GOLD DUST APARTMENTS

Preliminary Drainage Report

Stormwater review by Jennifer Lynch
JLynch@ScottsdaleAZ.gov
480-312-7903

10050 N Scottsdale Road, Paradise Valley, AZ

C4.2

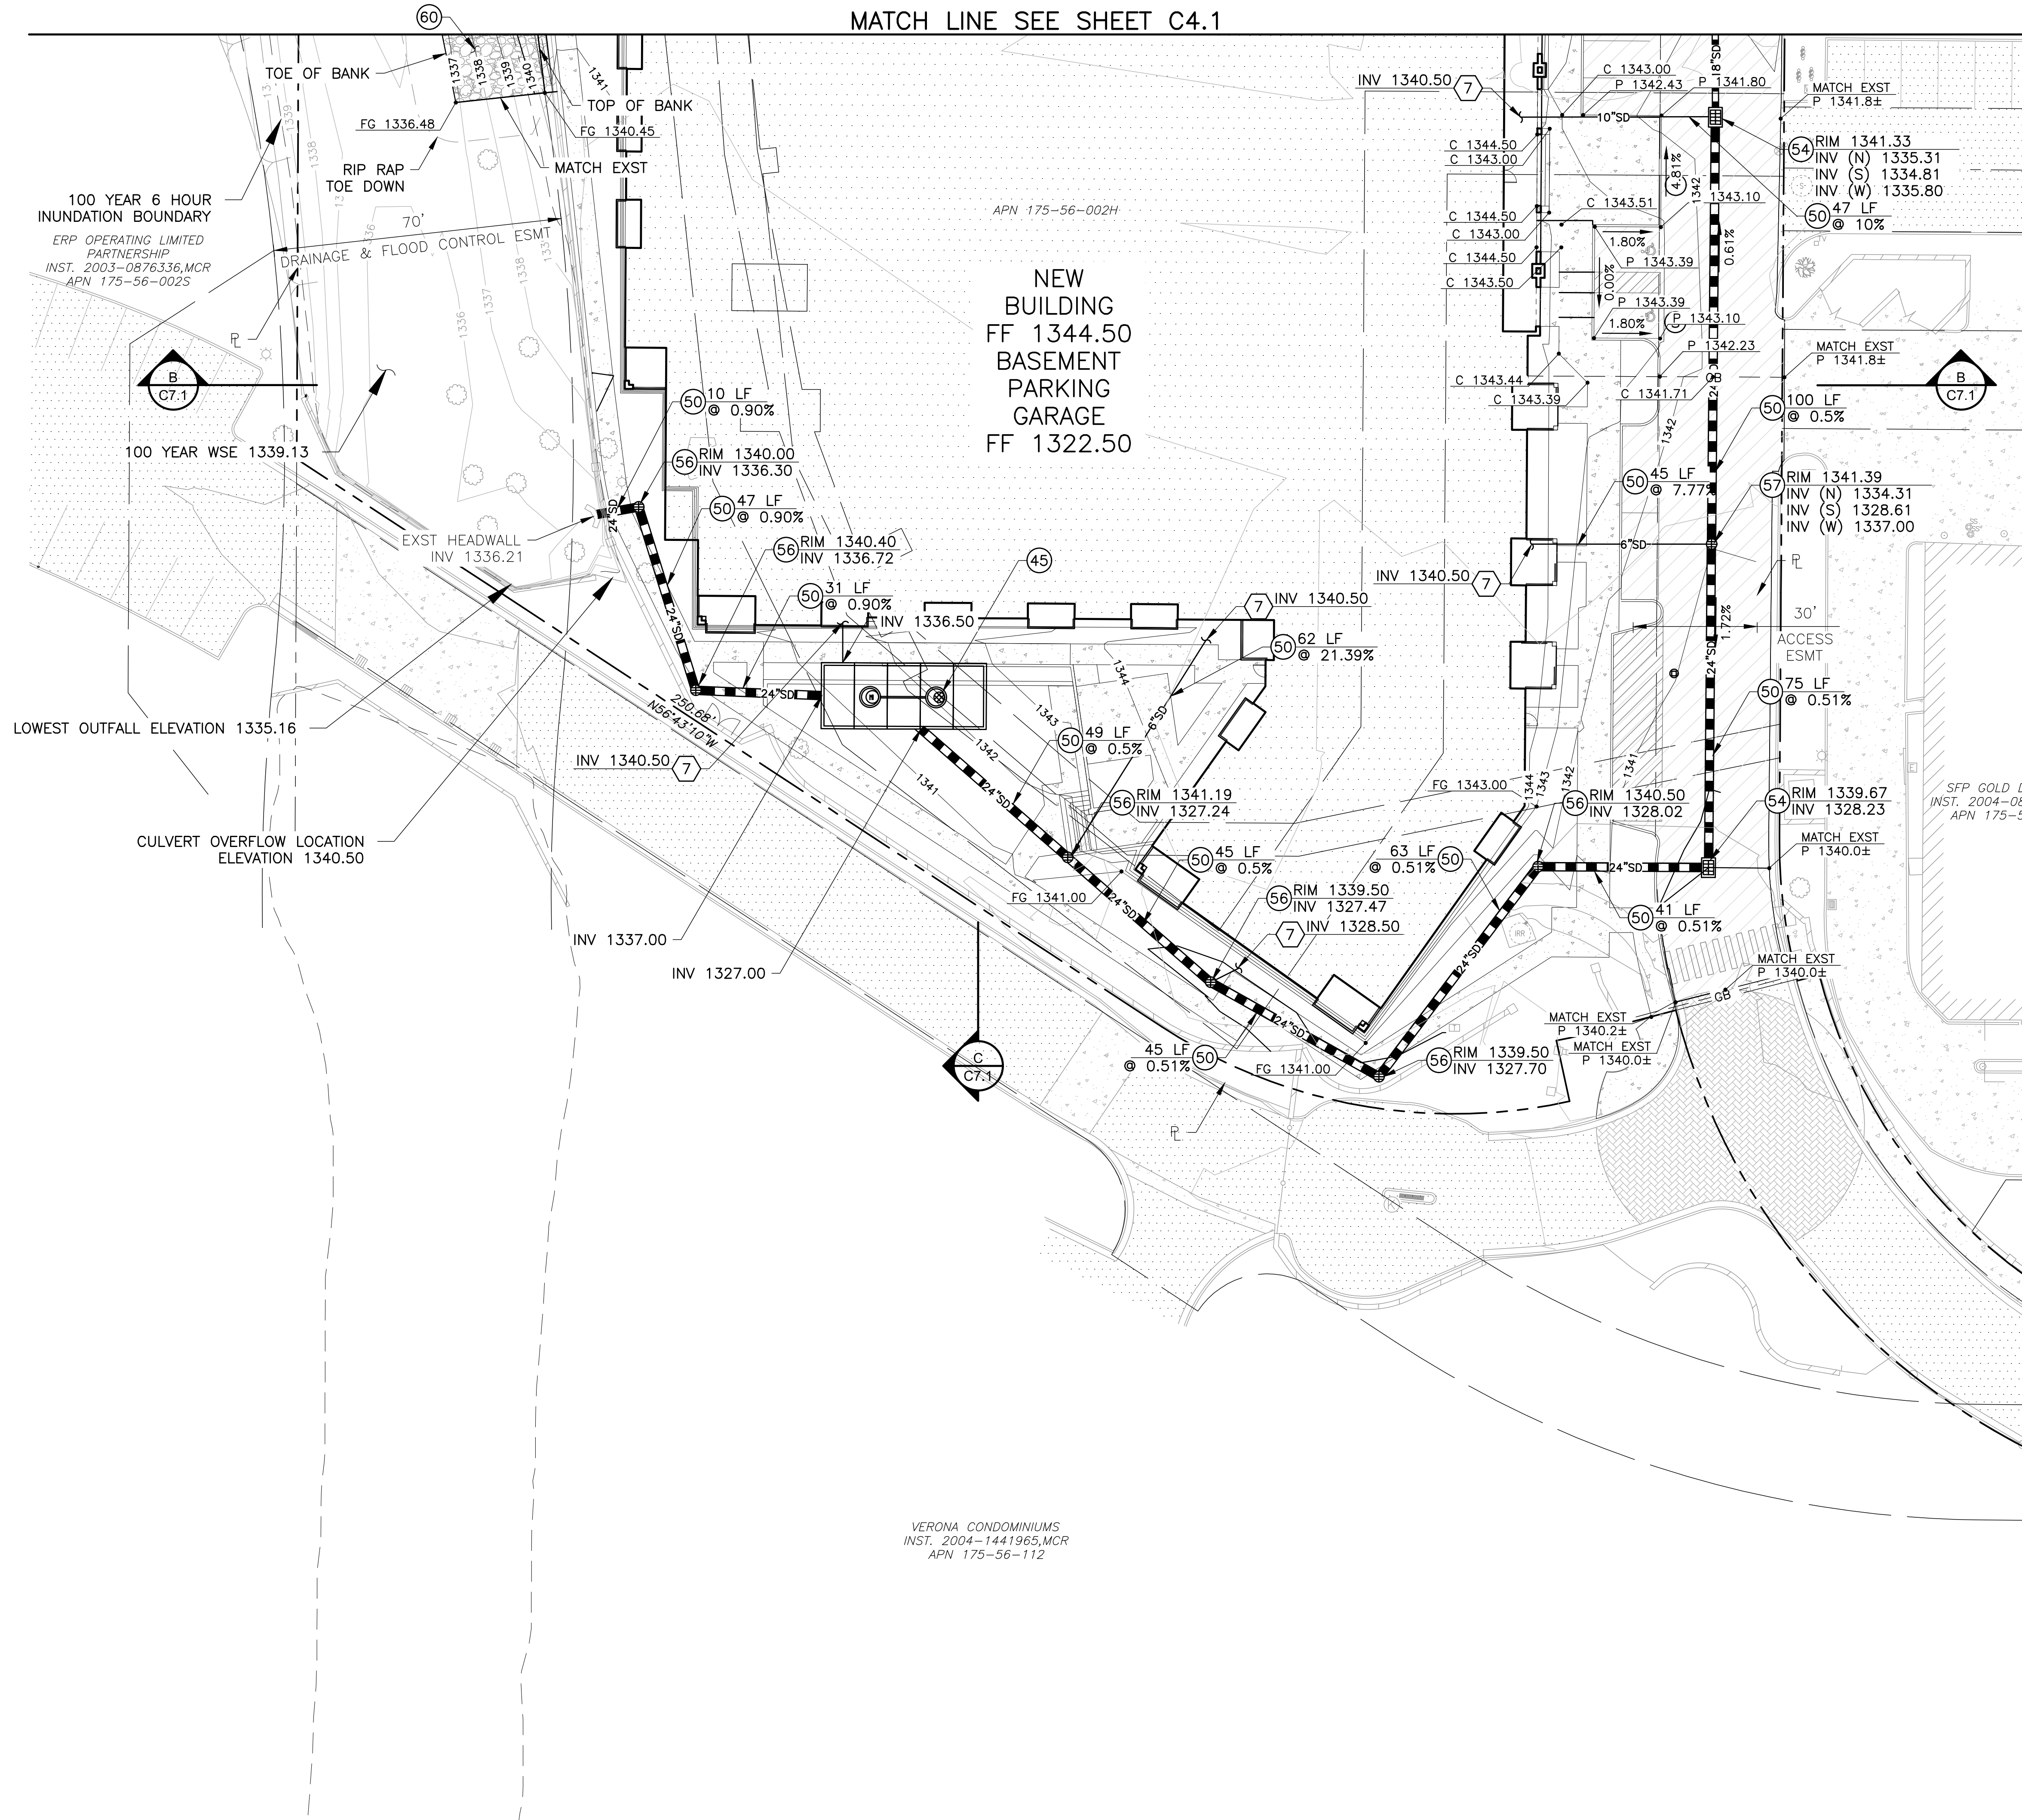
- CONSTRUCTION NOTES**
- (45) DUAL CHAMBER DRYWELL
MAXWELL PLUS OR APPROVED EQUAL
DET X, SHEET X
 - (50) STORM DRAIN, HDPE (WATER TIGHT)
SIZE PER PLAN
ADS N-12 WT OR APPROVED EQUAL
 - (54) DRAIN BASIN W/ 2'x3' MAG. GRATE
(H-20 TRAFFIC), DET X, SHEET X
ADS NYLOPLAST OR APPROVED EQUAL
 - (56) DRAIN BASIN W/ GRATED LID (PEDESTRIAN)
DET X, SHEET X
ADS NYLOPLAST OR APPROVED EQUAL
 - (57) DRAIN BASIN W/ GRATED LID (H-20 TRAFFIC)
DET X, SHEET X
ADS NYLOPLAST OR APPROVED EQUAL
 - (60) RIP RAP BANK PROTECTION
PER TYPICAL SECTION C4.1
- Update notes in final plans.

Exhibit F-1

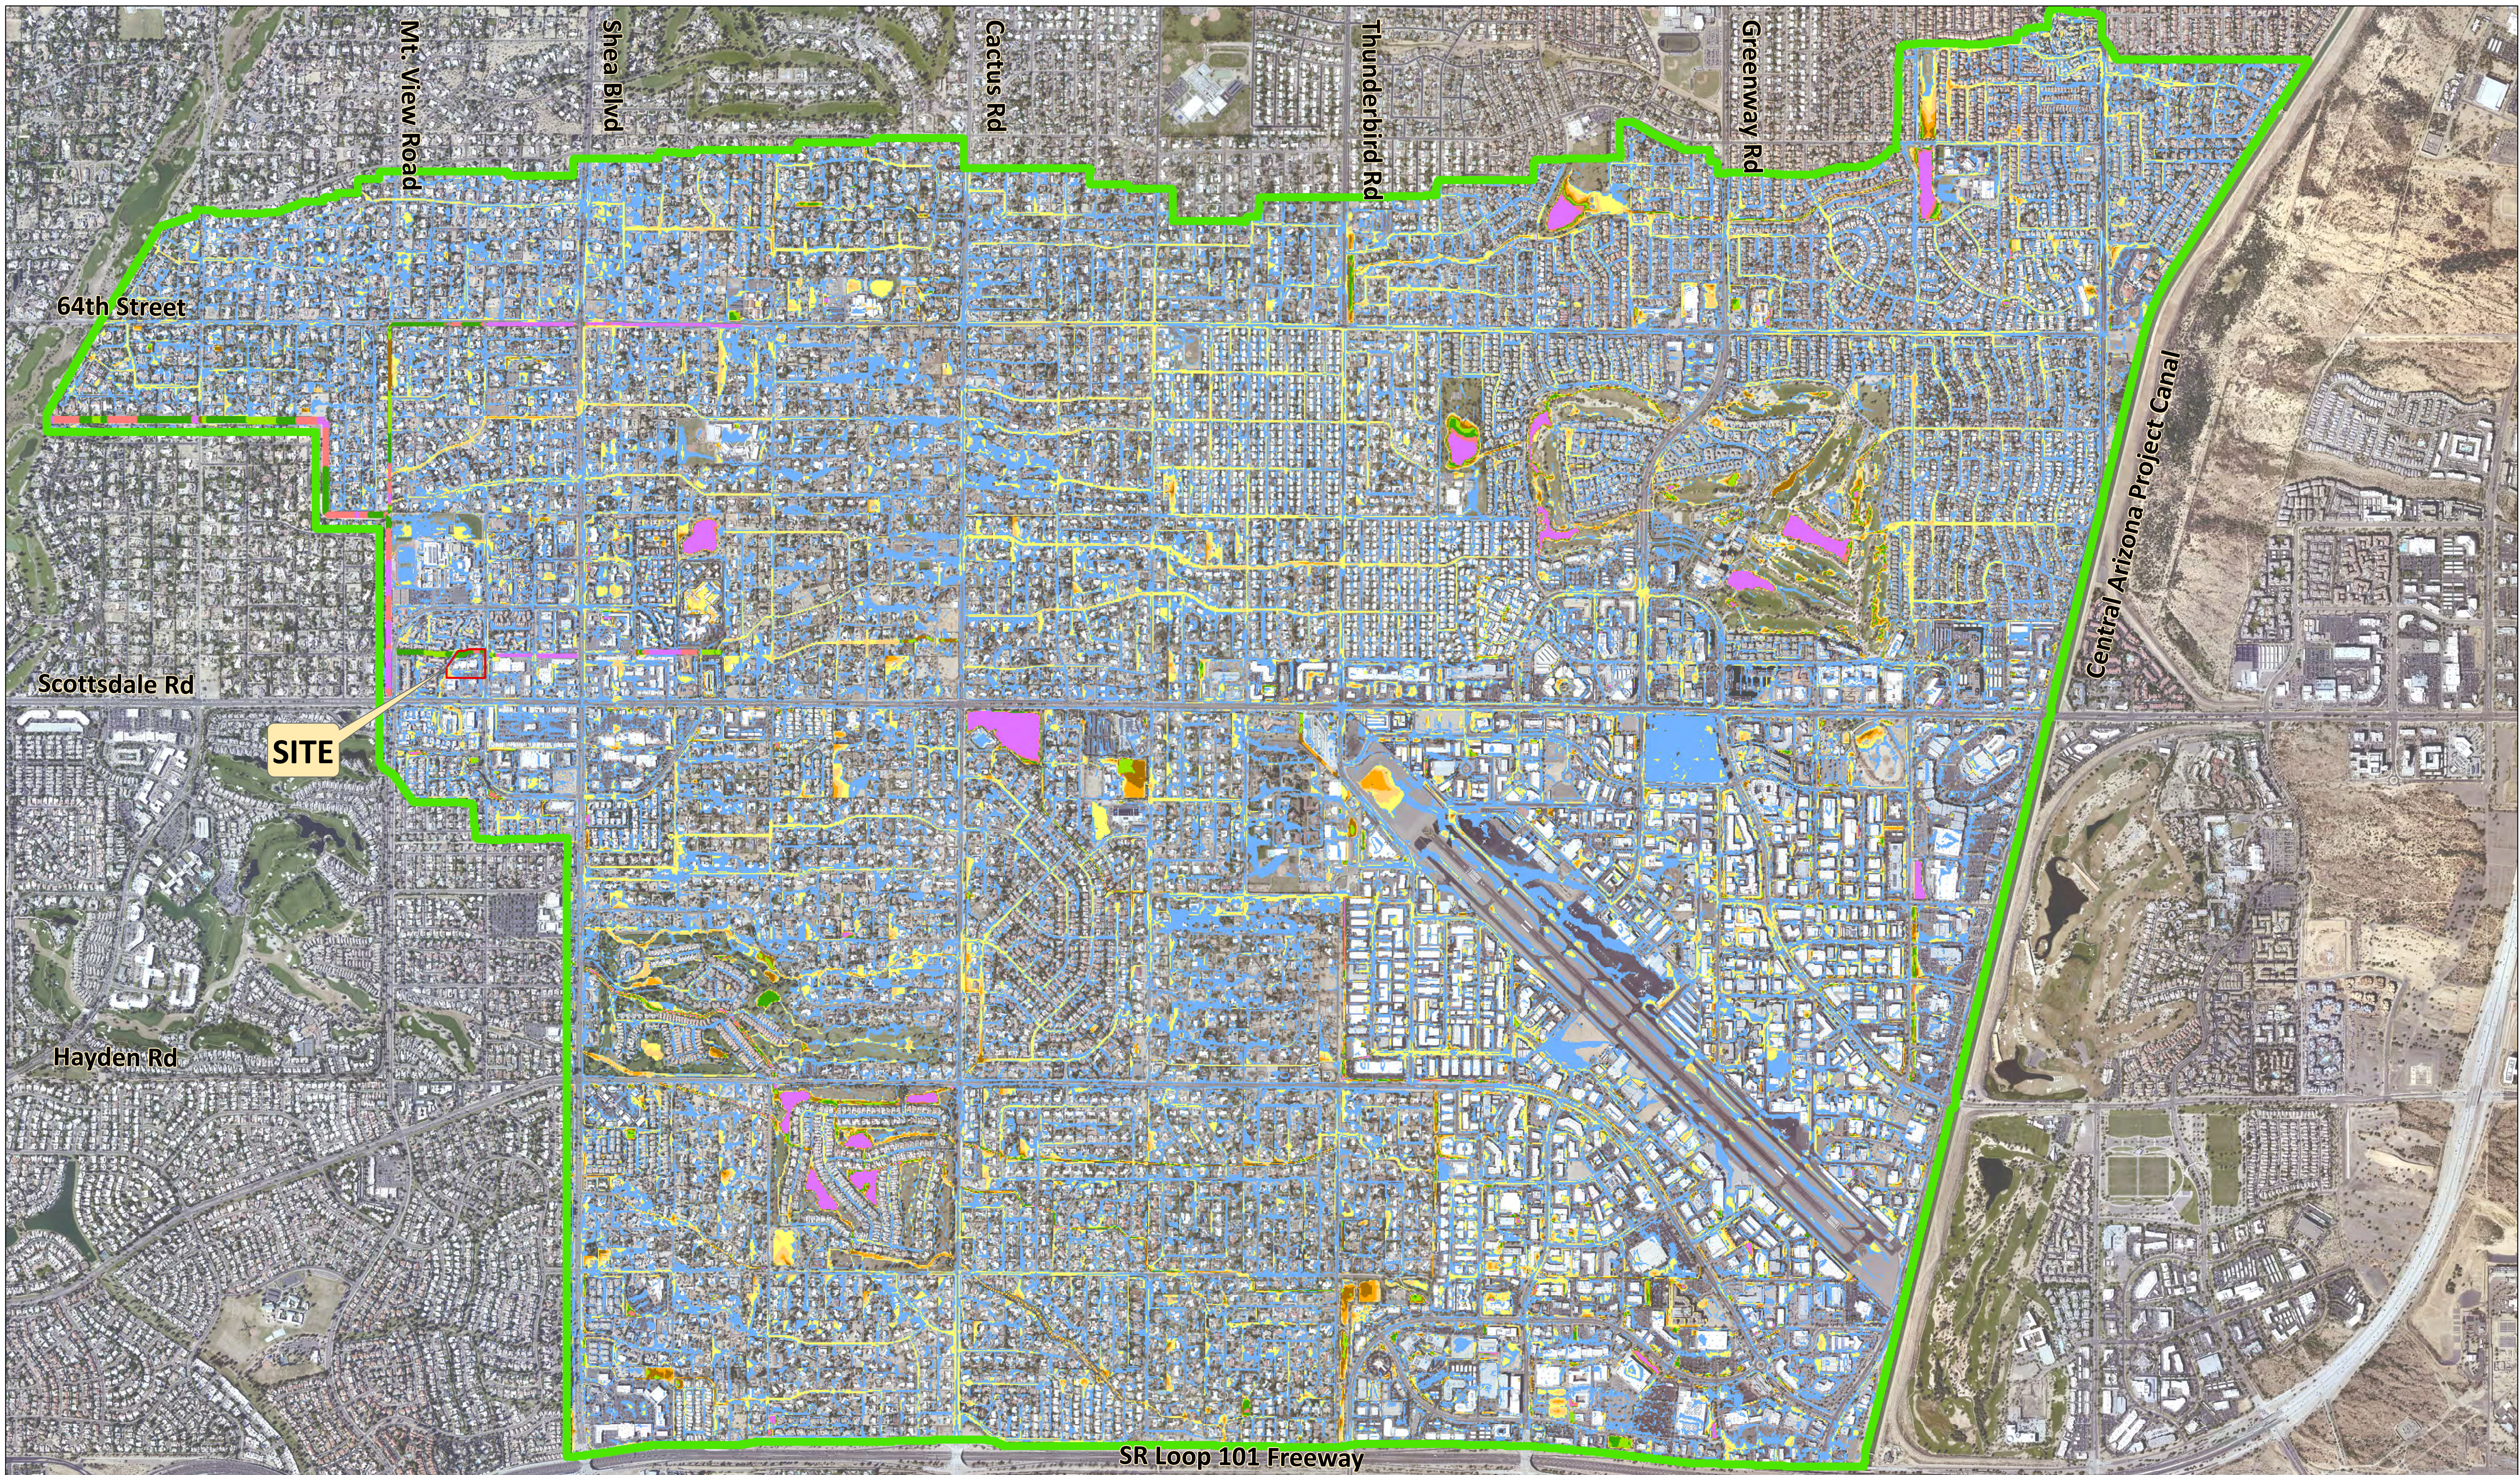
State the study this information is from.

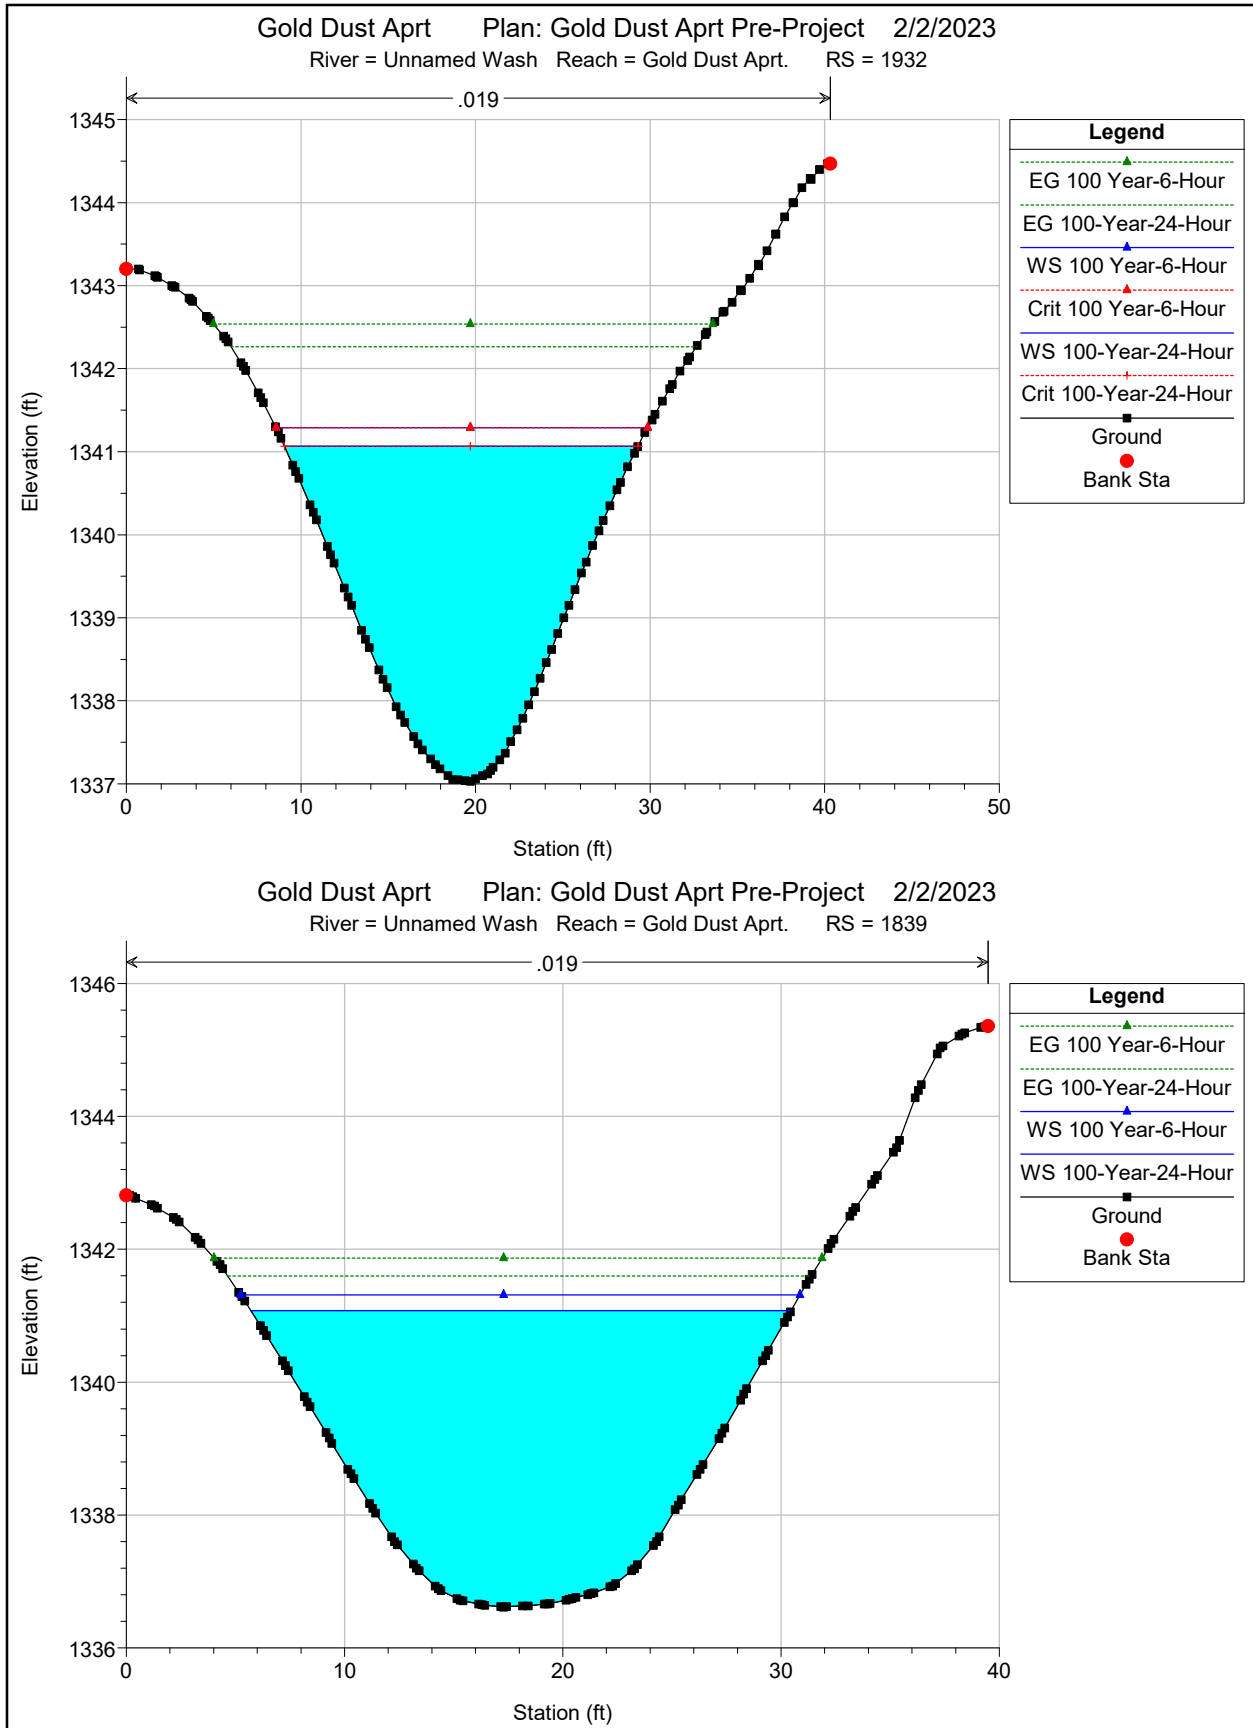
The n-value of 0.019 is not mentioned in the report. Where did it come from? Also, all bank stations are at the limits of the cross sections, please revise in final plans. (typ for all HEC-RAS)
